NOISE IMPACT STUDY

Response to Comments on 1st Submission

Proposed Housing Development,
6301 Campeau Drive
Kanata (Ottawa), ON

May 2021

Figure 4: Scale Plan

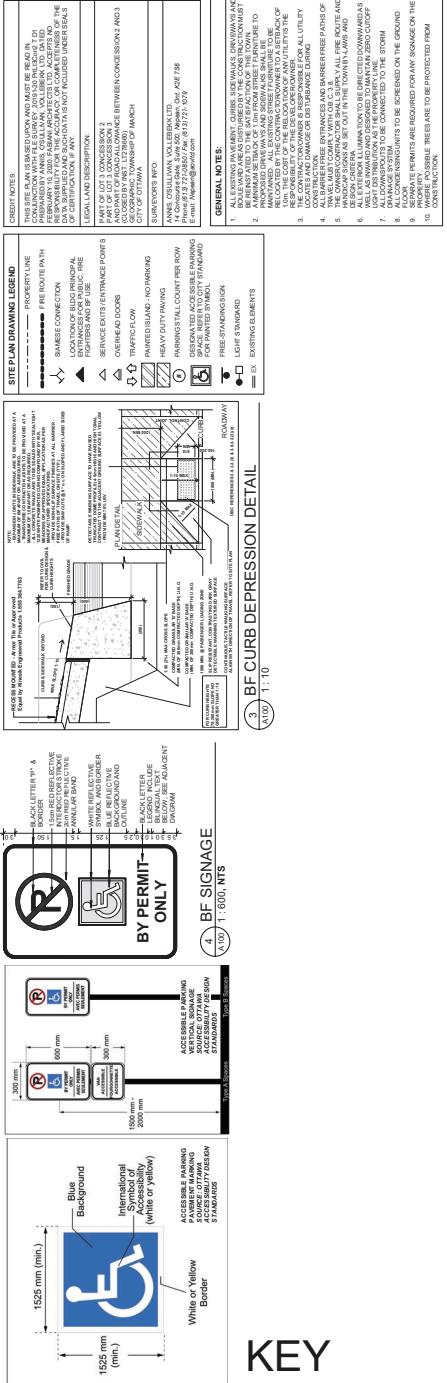
Comment 1: Please provide a scale plan identifying location of noise sources, receptor locations distance and angles between receptors.

Response: After confirmed with the City Staff, a scaled site plan noting the sources and receptors is provided in Figure 4.
